STAFF RECOMMENDATION
3708 Whitland Avenue
March 15, 2017

Application: New construction – outbuilding; Setback determination
District: Whitland Neighborhood Conservation Zoning Overlay
Council District: 24
Map and Parcel Number: 10409019800
Applicant: Nick Dryden, Architect
Project Lead: Sean Alexander, sean.alexander@nashville.gov

Description of Project: The applicant proposes to construct a new outbuilding at the rear of the lot. The proposal requires the determination on the appropriateness of an eighteen foot (18') left side (street facing) setback and a five foot (5') rear setback. A dwelling unit as a part of the outbuilding is not proposed.

SITE PLAN

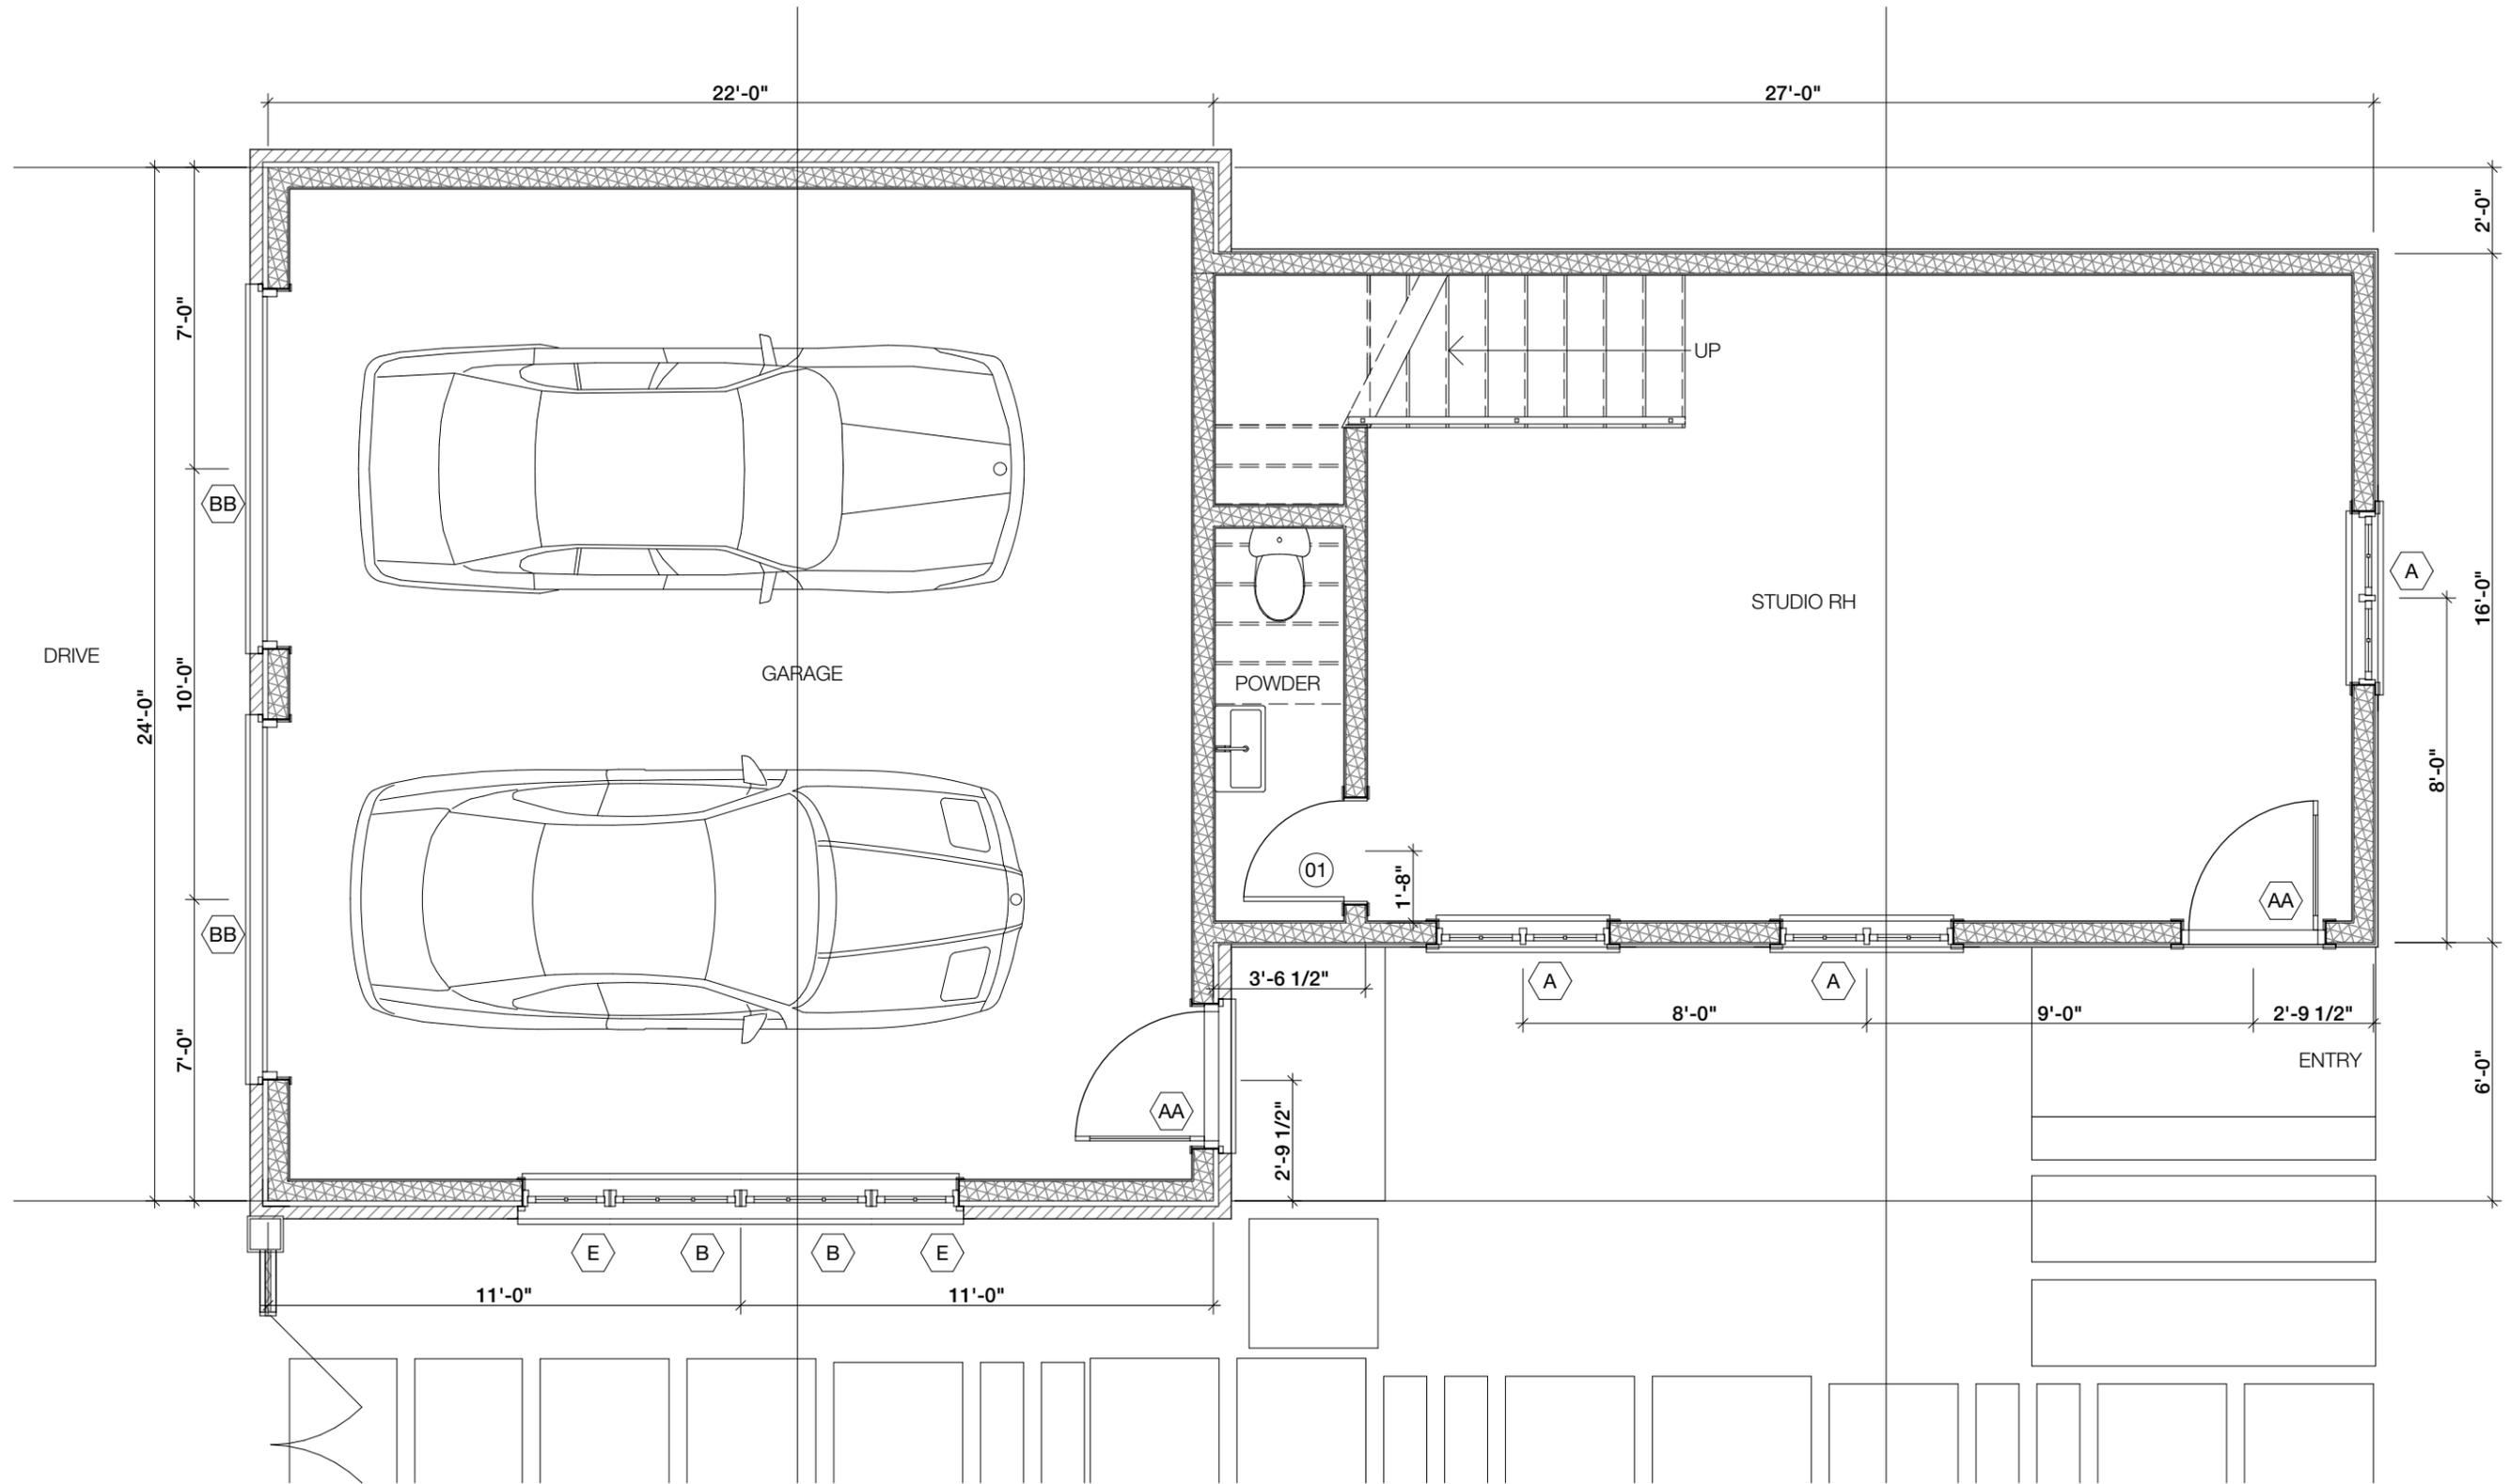
The new outbuilding does require a determination on the appropriateness of the proposed setbacks for the building. Bulk zoning would require minimum setbacks for the rear and left side (street-facing) to be twenty feet (20') for this building, however the applicant proposes to locate the building only eighteen feet (18') from the left side and five feet (5') from the rear of the property. Staff finds that the shorter setbacks to be in keeping with the location of outbuildings historically. Additionally, there is a fifteen foot (15') wide unpaved buffer along the edge of the property that gives the building the appearance of having a significantly deeper side-setback. The right-side setback is also typical of the

locations of outbuildings historically and meets the bulk zoning requirements. Staff finds the proposed outbuilding to meet section II.B.1.i.2 of the design guidelines.
